REGIONAL REVIEW NOTICE

ARC REVIEW CODE: R1611211

Name of Proposal: Nexus Town Center (DRI #2635)

NEXUS TOWN CENTER DRI
City of Doraville
Natural Resources Division Review Comments
November 16, 2016

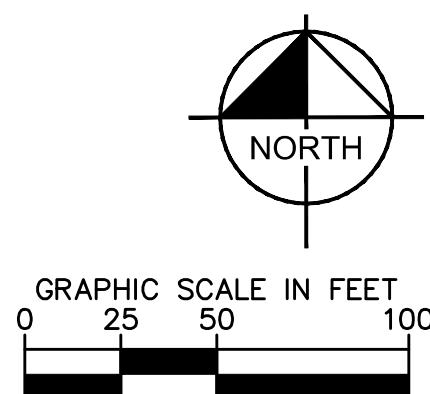
The project proposes six (6) driveways, two from a private drive, however the site plan does not depict limited access for the various modes. Commercial uses are saturated in the front of the parcel along

Buford Highway with residential uses in the rear of the site. Sidewalks are provided internal to the site however the site plan does not depict designated travel lanes for other modes internal to the site.

The goal is always to provide safe facilities and access for all travelers. ARC encourages developers whenever possible, to consider minimizing the intermingling of pedestrian and bicycle traffic from truck and freight traffic by designating facilities to serve the separate modes.
